Historic Preservation Board

Wednesday, February 7, 2024 at 5:00 PM
Room 24, Basement Level of City Hall
and Via Zoom

TO: Chair O'Brien and Members of the Historic Preservation Board
FROM: Rob Wiener, Historic Preservation Compliance Coordinator
DATE: February 2, 2024
RE: 106 Pine Street - PUBLIC HEARING – Add Basement Access Door and Stairs
PROJECT ID: HPBR-002605
MEETING: February 7, 2024

**STAFF MEMORANDUM
HISTORIC PRESERVATION PROGRAM
PLANNING AND URBAN DEVELOPMENT**

106 PINE STREET
PORTLAND, ME

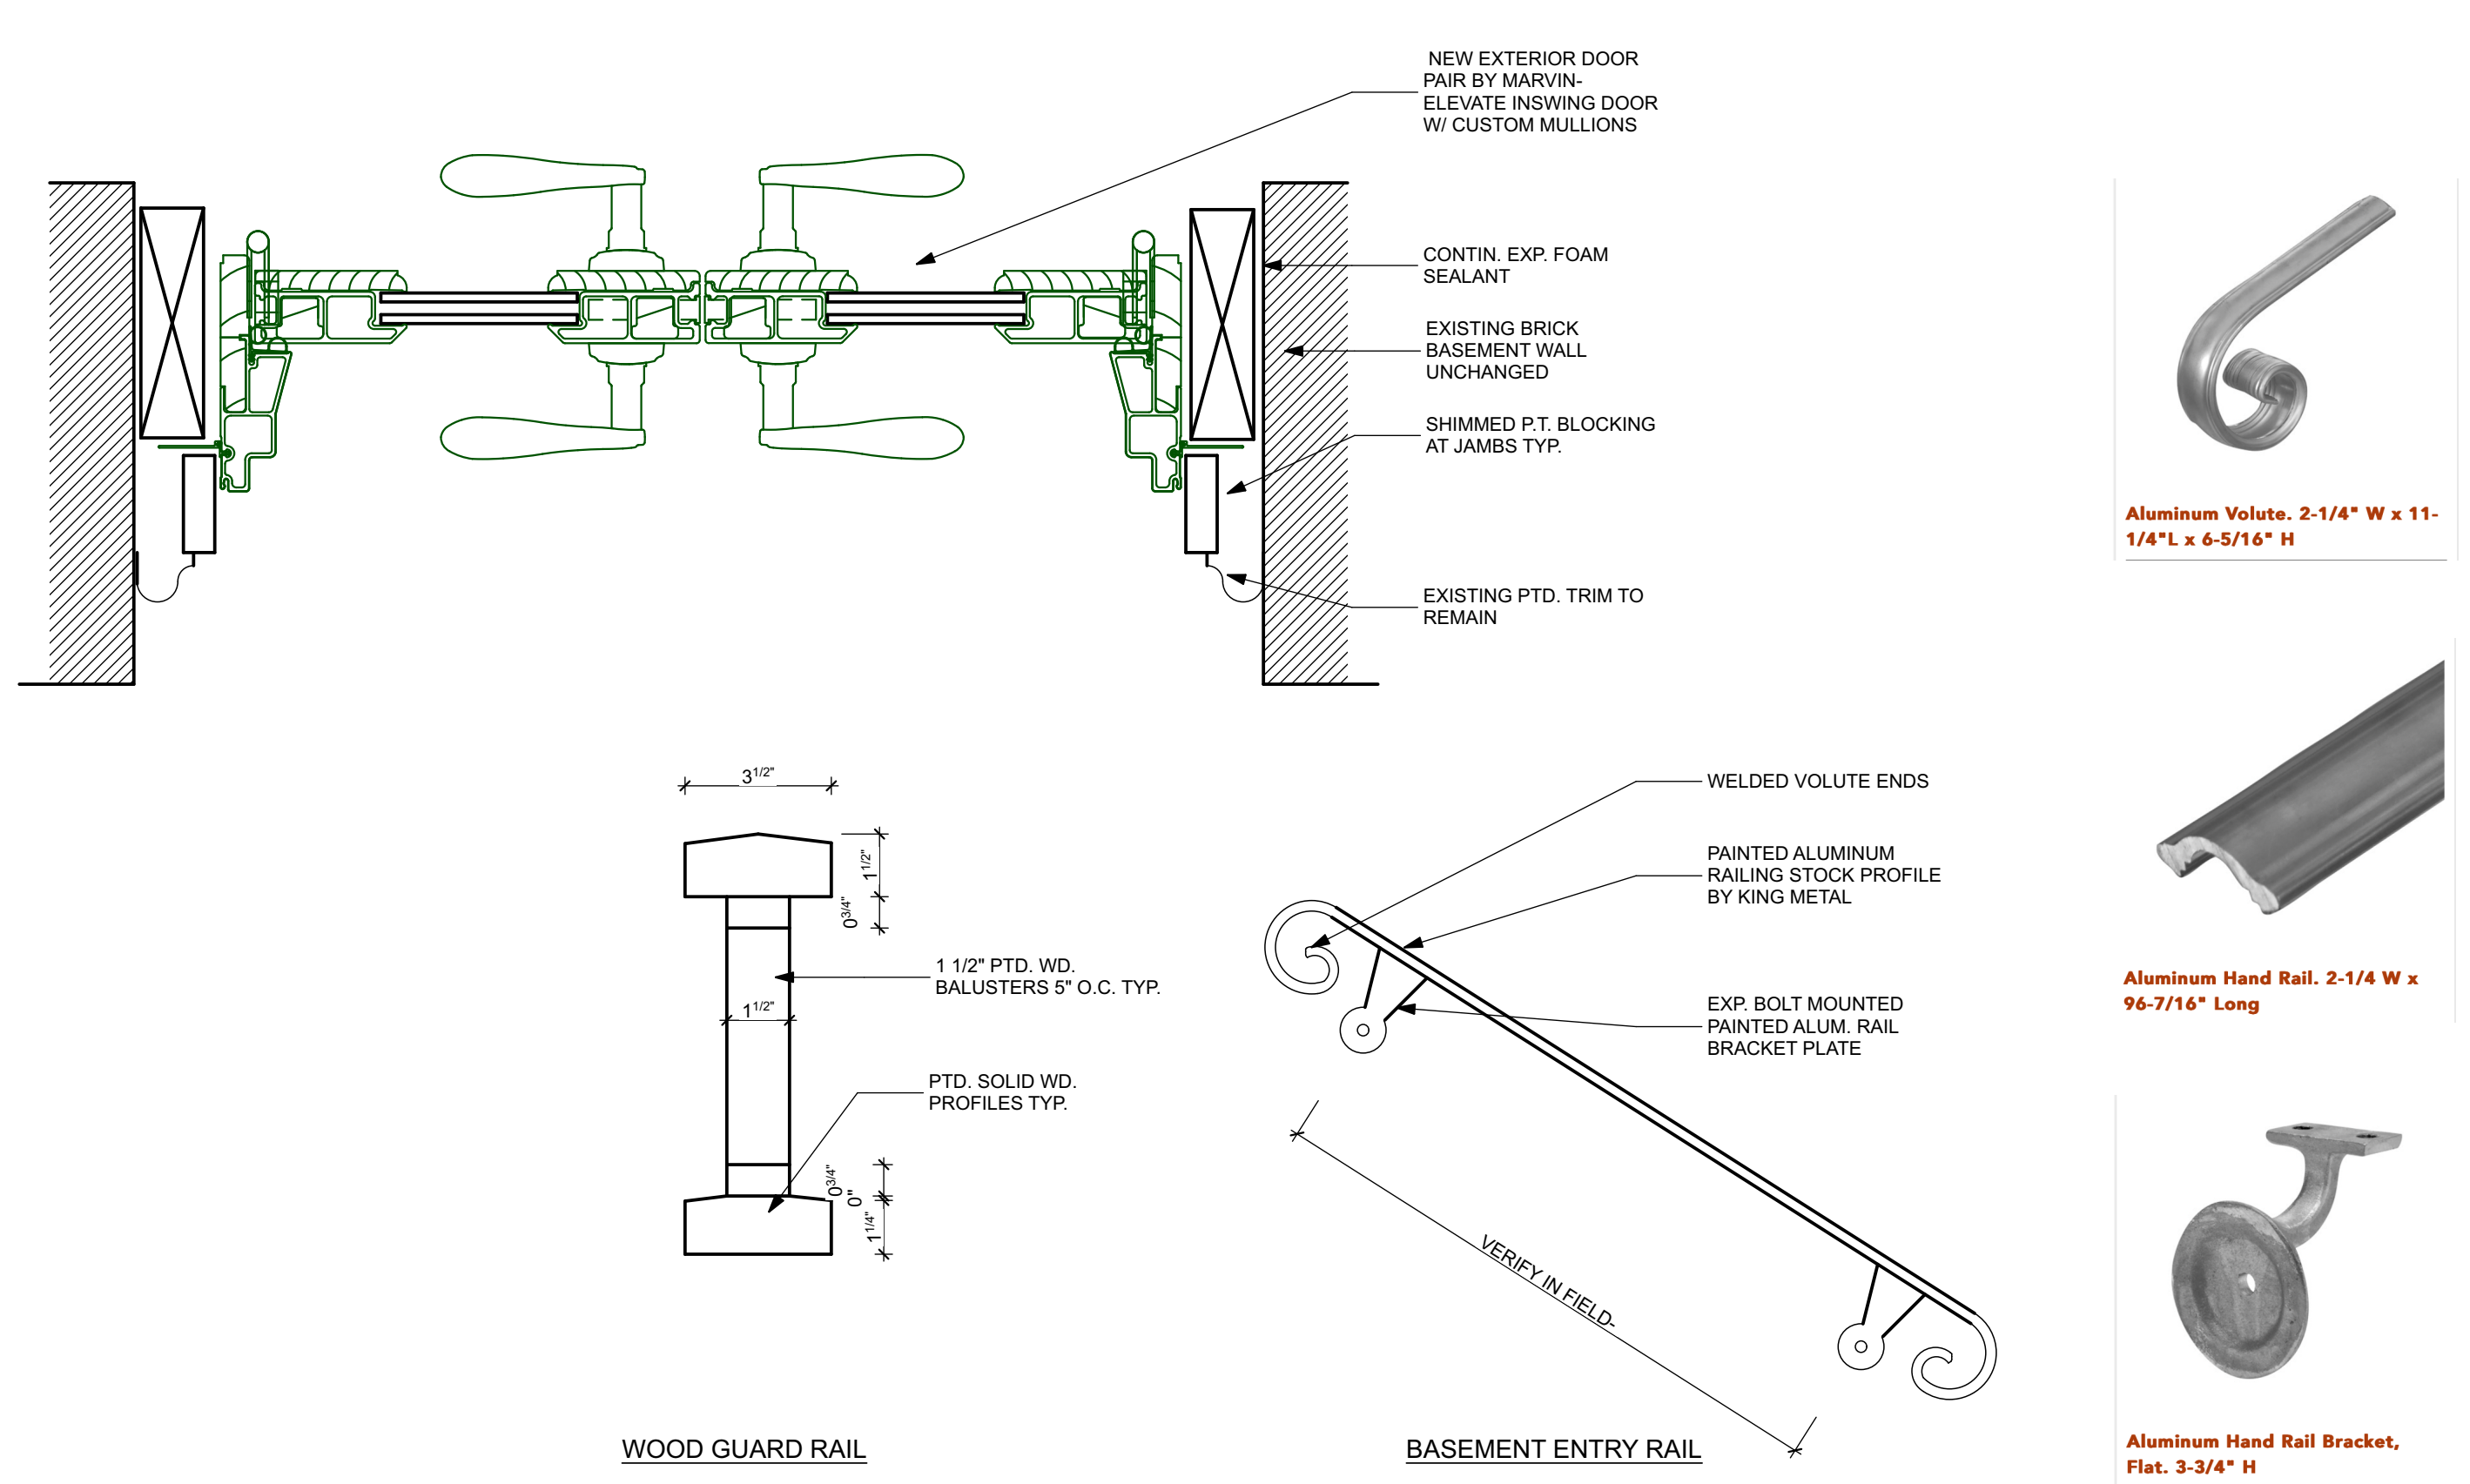
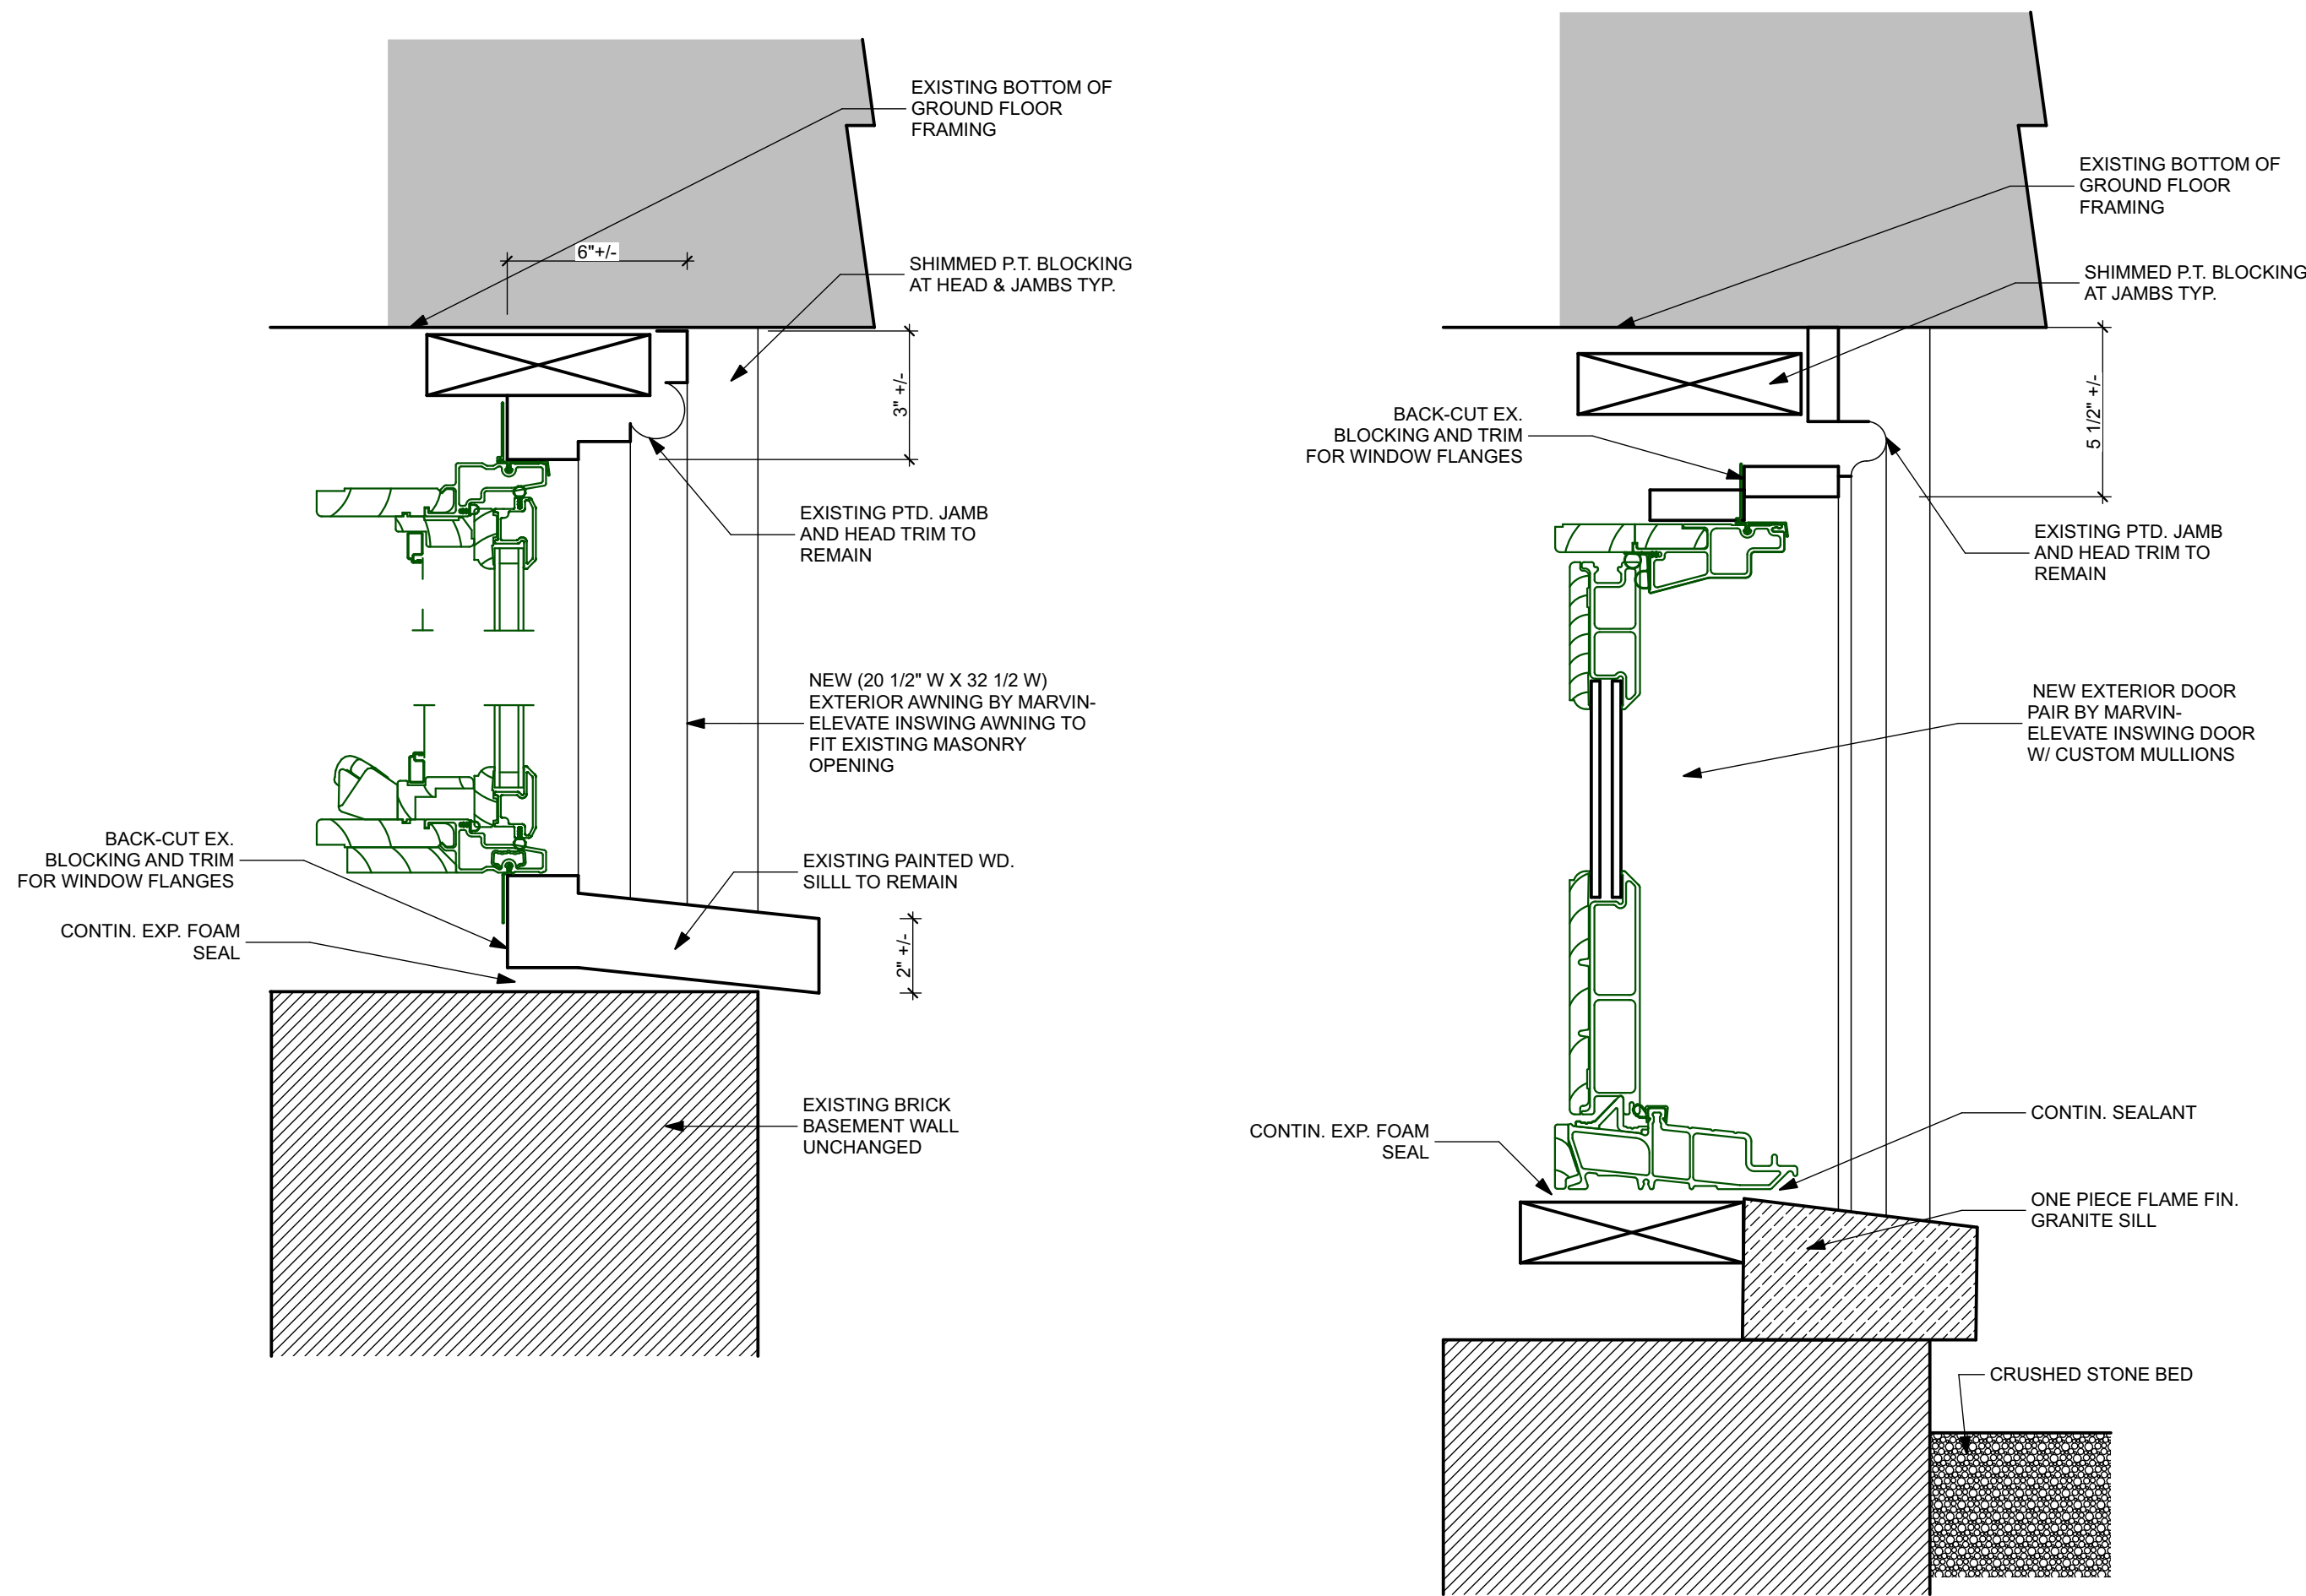
- Please provide details on lighting, handrail for the stairs, and the guard rail at grade.
- It was recommended that the visible guardrail should be a painted wood, traditional balustrade compatible with the nearby existing porch.
- Also recommended was enhancement of the garden path landing at the top of the stairs.

The proposed access stair will have flame faced granite treads and stacked stone retaining walls. Footings and piers are located/ hidden within the wall to anchor the posts for the proposed guard. We hope to work with Libby Masonry, who has visited the site. They felt that the small area of exposed existing foundation can be reworked with new stone for a consistent look. The guard will be painted wood as detailed and are designed to match the existing porch railings.

The proposed wall mounted painted metal handrail will be based upon aluminum profiles by King Metals. The graspable run will have a volute detail welded at each end. Two aluminum wall brackets will be provided. The aluminum will minimize corrosion/ staining and hold paint well.

The stair well will be lit with two step lights recessed into the stone wall. They are 3" x 5" and have dark bronze housings with full cutoff lights. The lights are located to be minimally visible from the sidewalk and to provide low level intensity.

Figure 4: Applicant rendering of the proposed project.

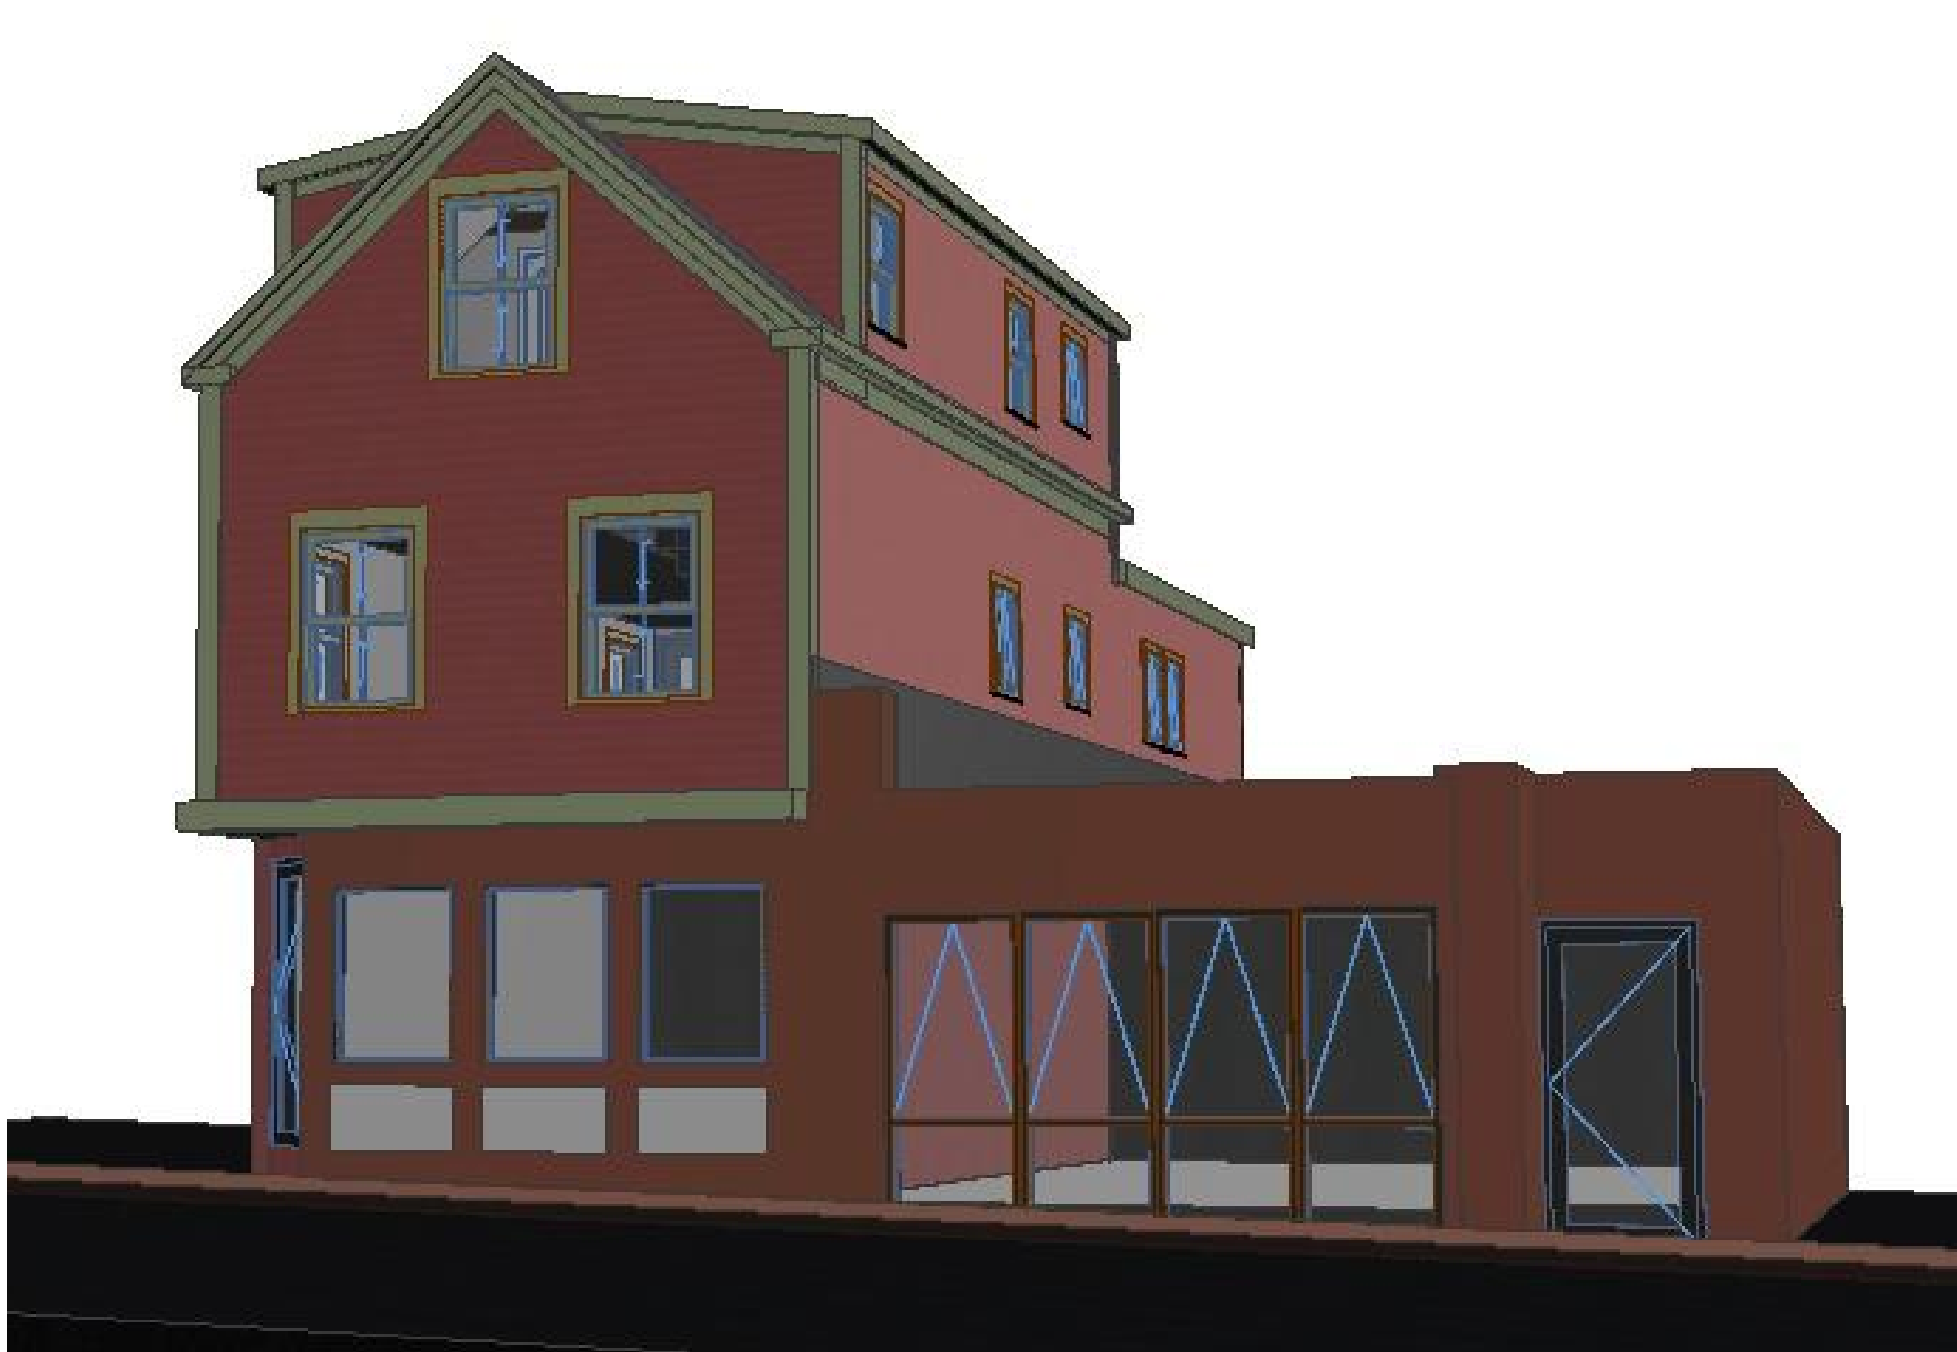
The applicant is looking to address structural issues at the roof of this noncontributing building while creating a code compliant and more usable third floor. In order to achieve this, the applicant is proposing to remove the existing roof and construct a new roof of the same slope about eighteen inches higher than the existing. Paired with this, the applicant is proposing to add symmetrical shed-roof dormers on both sides of the building. These dormers will be set back about four feet from the front façade and the side elevations will feature false eaves above the second floor to retain the gable-ended look of the existing structure. The existing shed-roof

In addition to the alterations at the top floor, the applicant is proposing to re-side the whole structure and replace windows. The 1924 tax photo shows very spartan Greek-revival trim, clapboard siding, and two-over-two windows throughout. All of these elements have since been replaced; however, the applicant is proposing to restore them to some degree. This would include simplified trim details based on proportions of the original structure, wood siding at the front elevation, with fiber-cement siding at the sides and rear. The applicant is also proposing to install two-over-two windows at the front elevation.
